Access Compliance Report Public Rights-of-Way (Curb Ramps)

Intersection ID: 30070 Main Street: SOUTHWIND_DR Cross Street: WATERS_TRAIL_DR Location: NE

ADA ID: BADA8CEC4627 Ramp Type: BlendTrans1 Initial Pass/Fail: Fail Overall Compliance: No Severity Score: 12.5

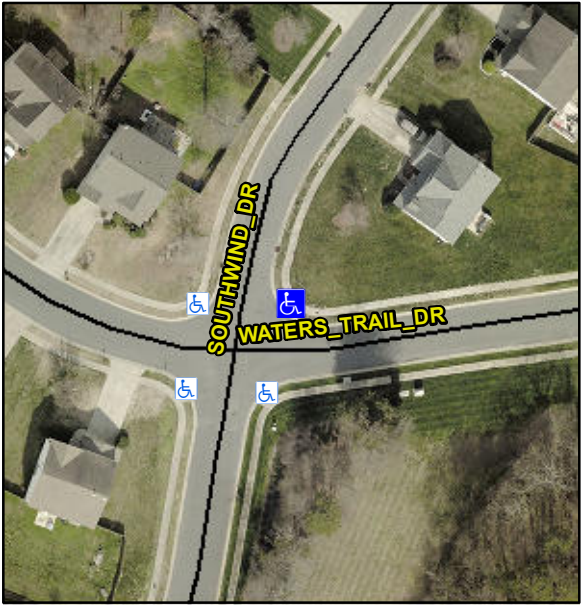
PROW/ADA:
Not Found, R304.5.3

Compliance	Description	Data	Compliance	Description	Data
N/A	Ramp Length (in)	49.5	Yes	BlendTrans Slope (%)	4.8
Yes	Ramp Width (in)	48.5	No	BlendTrans XSlope (%)	5.5
N/A	Flare Type LT	N/A	N/A	Flare Type RT	N/A
N/A	Flare Slope LT (%)	N/A	N/A	Flare Slope RT (%)	N/A
N/A	Flare Traversable LT?	N/A	N/A	Flare Traversable RT?	N/A
N/A	Landing Length (in)	N/A	N/A	DWS Provided?	N/A
N/A	Landing Width (in)	N/A	N/A	DWS Contrast?	N/A
N/A	Landing Slope (%)	N/A	N/A	DWS Length (in)	N/A
N/A	Landing X Slope (%)	N/A	N/A	DWS Full Width?	N/A
N/A	Landing Curb? (Y/N)	N/A	N/A	DWS Offset (in)	N/A
N/A	Shared Landing?	N/A			
N/A	Gutter Ponding?	N/A	N/A	Gutter Slope (%)	N/A
N/A	Gutter Lip Ht (in)	N/A	N/A	Gutter X Slope (%)	N/A
N/A	Painted X Walk1?	No	N/A	Painted X Walk2?	No
	X Walk 1 Direction	To W		X Walk 2 Direction	To S
	X Walk 1 Width (in)	N/A		X Walk 2 Width (in)	N/A
	X Walk 1 Slope (%)	0.2		X Walk 2 Slope (%)	0.2
	X Walk 1 X Slope (%)	1.4		X Walk 2 X Slope (%)	3.3

N/A	Ramp inside XWalk1?	N/A	N/A	Ramp inside XWalk2?	N/A
	Road Slope (%)	3.5		Clear Space?	N/A
	Road X Slope (%)	0.6	N/A	Clear Space to XWalk (in)	N/A
N/A	Any Obstructions?	N/A	N/A	Storm Grate/Utility Hazard?	N/A
	Obstruction Type			Storm Grate/Utility Type	
		N/A			N/A
Yes	Surface Condition? (G/P)		Yes		Good
No	Curb Slope (%)		No		7.0

Possible Solutions:
Remove & Replace Curb Ramp With Two New Directional Ramps or Equivalent.
